Subject: Waiver of 30-day Review Period
File No. 1050051-015-AC, PSD-FL-321
US Agri-Chemicals

Subject: Response to FDEP request for Additional Information
Granular MAP/DAP Production Increase
US Agri-Chemicals, Ft. Meade Chemical Plant
DEP File No. 1050051-015-AC, PSD-FL-321

Re: DEP File No. 1050051-015-AC; PSD-FL-321
Granular MAP/DAP Production Increase
Ft. Meade Chemical Plant

FIGURE 4-1

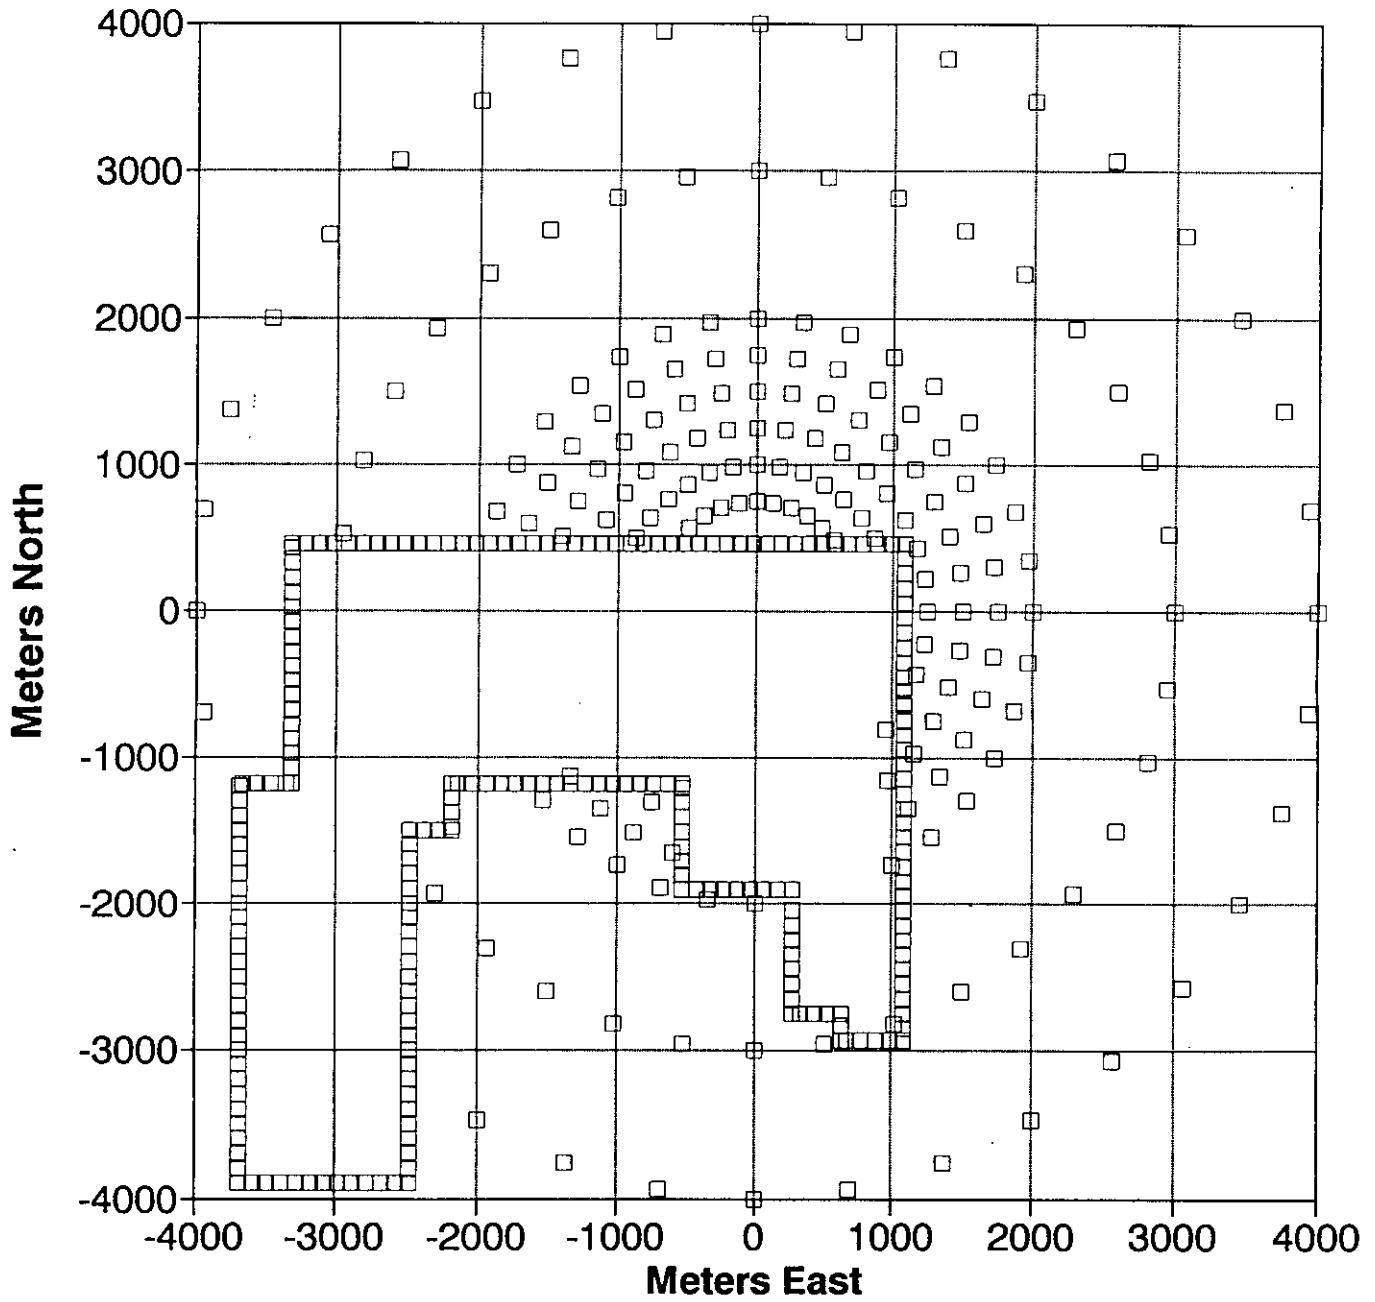
6. In Table 4-1 and in the modeling output there are discrepancies between the stack parameters (especially the stack heights) used for the existing 50 TPH particulate case and the 60 TPH particulate case. The stack height for the existing Tower is given as 21.95 meters while the stack height for the projected case is 41.30 m. However, in the fluoride case the stack heights do not change between the existing case and the projected case. Which is correct? If the stack heights are being raised, please explain the purpose of raising the stacks.
7. In Figure 4-1 and in the modeling, receptors were placed only on the eastern part of the property. Receptors should be located along and away from the entire fenced plant boundary not just a portion of it. Please include additional receptors along the western and southwestern property boundaries.

7. A summary of the revised modeling, based on the additional receptors requested by FDEP, is presented in Attachment 2. The additional receptors selected are located within the USAC property boundary thus providing a conservative analysis. A detailed discussion was previously submitted to FDEP justifying the actual USAC property boundary as precluding access to the general public. As FDEP has reviewed and approved that fence-line protocol, additional details are not presented herein.

The revised modeling resulted in maximum predicted PM impacts below the significant impact levels. The maximum predicted fluoride impacts were below the de-minimus level (see Attachment 2).
